ZONING AMENDMENT,
PLANNED UNIT DEVELOPMENT &
SUBDIVISION STAFF REPORT

Date: December 21, 2006

<u>NAME</u>	University of South Alabama Foundation
<u>SUBDIVISION NAME</u>	The Madeira of Mobile Subdivision
<u>LOCATION</u>	West side of South University Boulevard, 750'+ South of Old Shell Road, extending to the North termini of Barbara Mitchell Drive East, General Bullard Avenue, and Westfield Avenue, and extending to the East side of Long Street, 900'+ South of Old Shell Road.
<u>CITY COUNCIL DISTRICT</u>	District 5
<u>PRESENT ZONING</u>	B-1, Buffer Business, B-2, Neighborhood Business, and B-3, Community Business
<u>PROPOSED ZONING</u>	B-1, Buffer Business
<u>AREA OF PROPERTY</u>	17.5 ± Acres
<u>CONTEMPLATED USE</u>	<p>Rezoning from B-1, Buffer Business, B-2, Neighborhood Business, and B-3, Community Business, to B-1, Buffer Business, to eliminate split zoning in a commercial subdivision and to allow an apartment complex, and unspecified commercial use, Planned Unit Development Approval for multiple buildings on a single building site for a 240 unit residential apartment complex, and Subdivision of four parcels into three lots.</p> <p>It should be noted, however, that any use permit

SITE PLAN

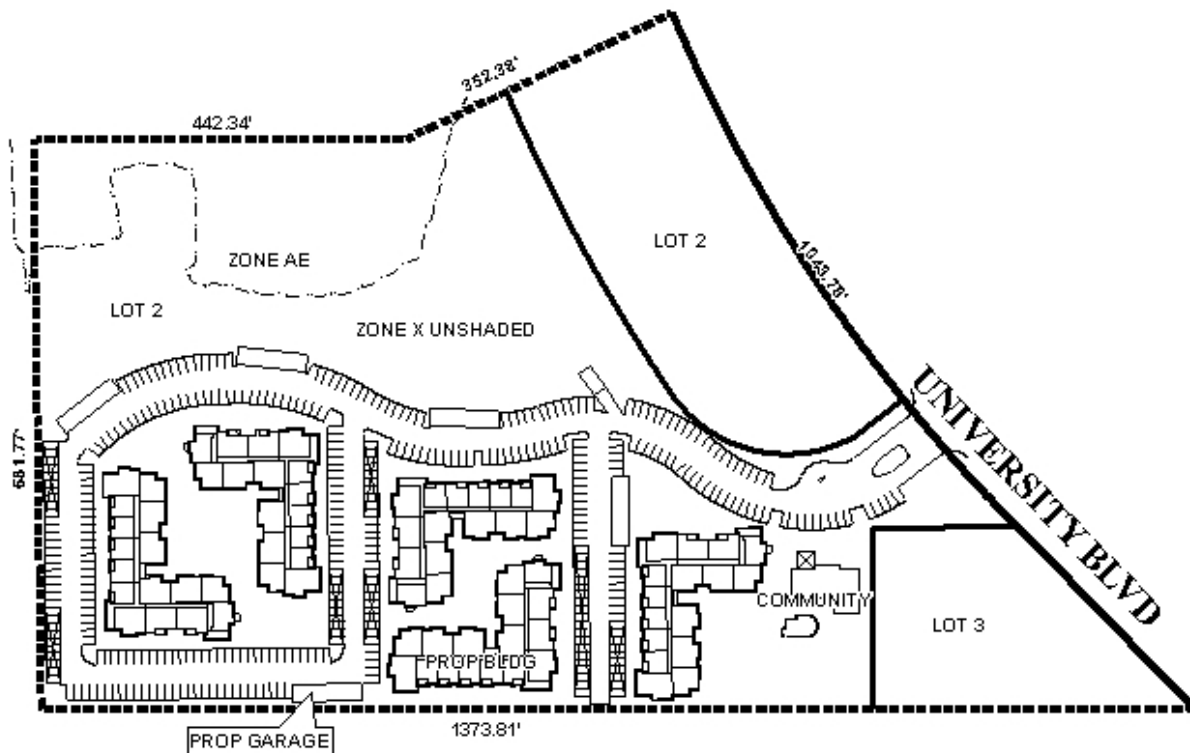
Internal vehicular circulation generally appears adequate, however, the parking area North of General Bullard Avenue does not provide adequate space for a fire truck to turn around. The applicant should consult with Fire Rescue to ensure that the internal vehicular circulation system meets their requirements, and the site plan should be accordingly revised.

No pedestrian circulation is depicted on the site plan, however, sidewalks should be depicted. The site plan should be revised to depict sidewalks within the PUD and along the University Boulevard street frontage. It should be noted that the WAVE transit system appears to have a route along University Boulevard. It should also be pointed out that University Boulevard is a five-lane roadway at this location, without a median, and that it is likely that the proposed apartment complex would generate residential traffic associated with the University of South Alabama, potentially associated with E.R. Dickson Elementary School, as well as adjacent retail and food-related services.

A location for a dumpster appears to be indicated on the site plan, however, the location is not labeled. The location of the storage area for the dumpster must be indicated on the site plan, and the location and required screening must comply Section 64-4.D.9. of the Zoning Ordinance, as well as with all other applicable regulations.

It also appears that two of the proposed carports on the West side encroach upon the required setback from Long Street, and three of the structures encroach upon the 25-foot setbacks that project from the street-stubs along the southern boundary of the site. The site plan should be revised to ensure that all structures meet setback requirements delineated in the Zoning Ordinance and the Subdivision Regulations, and that appropriate adjacency buffers are depicted where the site abuts residentially-developed property (residentially-zoned property that is undeveloped can remain unbuffered until such time the sites are developed with single-family homes).

The minimum building setback line required in Section V.D.9. of the Subdivision Regulations is not shown for the lots, but would be required on the final plat and site plan. The minimum building setback line should be depicted from all street frontages, including the street stubs along the southern portion of the site.

Planned Unit Development: The PUD request is recommended for Holdover until January 18th, with revisions due to Urban Development by December 27th, to give the applicant time to address the following: 1) revision of the site plan and subdivision plat to depict compliance with Engineering comments (*Flood zone should be depicted on plat based on the flood zone limits from FIRM maps, not based on elevation. Show minimum finished floor elevation on each lot. Show drainage easements. Must comply with all storm water and flood control ordinances. Any work performed in the right of way will require a right of way permit.*); 2) revision of the site plan and subdivision plat to depict compliance with Forestry comments (*Property to be developed in compliance with state and local laws that pertain to tree preservation and protection on both city and private properties (State Act 61-929 and City Code Chapters 57 and 64). Preservation status is to be given to the 60" Live Oak Tree located on the East side of Lot 1. Any work on or under this tree is to be permitted and coordinated with Urban Forestry; removal to be permitted only in the case of disease or impending danger.*); 3) revision of the site plan to indicate the total number of parking spaces, including within garages, the total size of the "community building," the number of stories of all buildings, and labeling of the proposed pool; 4) consultation with Fire / Rescue to determine if modifications to the site plan are necessary to comply with their regulations, and revision of the site plan as appropriate; 5) revision of the site plan to depict compliance with the open space and tree and landscaping requirements of the Zoning Ordinance, including the necessary site calculations required by Section 64-5.C.2. of the Zoning Ordinance; 6) depiction and labeling of any required stormwater detention basins; 7) depiction and labeling of dumpster locations, with screening that complies with Section 64-4.D.9. of the Zoning Ordinance; 8) revision of the site plan to ensure that all proposed structures

meet setback requirements, and depicted of the minimum building setback line on both the site plan and the subdivision plat; 9) provision and depiction of a 10-foot wide vegetative buffer and 6 to 8 foot high privacy fence or wall where the portion of the site to be developed abuts adjacent R-1 districts that are developed with single-family residences; 10) placement of a note on the site plan stating that maintenance of all common areas and detention areas is the responsibility of the property owners; 11) placement of a note on the site plan stating that lighting shall be so arranged that the source of light does not shine directly into adjacent residential properties or into traffic, per the requirements of Section 64-4.A.2. the Zoning Ordinance; 12) depiction of the pedestrian circulation system on the site plan, including the depiction of a sidewalk along University Boulevard; 13) placement of a note on the site plan and plat stating that the approval of all applicable federal, state and local agencies prior to the issuance of any permits or land disturbance activities; and 14) placement of a note on the site plan and subdivision plat stating that Lot 1 is limited to one curb-cut onto University Boulevard and denied access to Westfield Avenue, General Bullard Avenue, and Long Street (until Long Street is constructed to city standards from the site North to Old Shell Road, at which time Lot 1 should be limited to two curb-cuts), Lots 2 and 3 are limited to two curb-cuts each onto University Boulevard, that Lot 3 is denied access to Barbara Mitchell Drive East, and that the size, design and location of all curb-cuts must be approved by Traffic Engineering and conform to AASHTO standards.
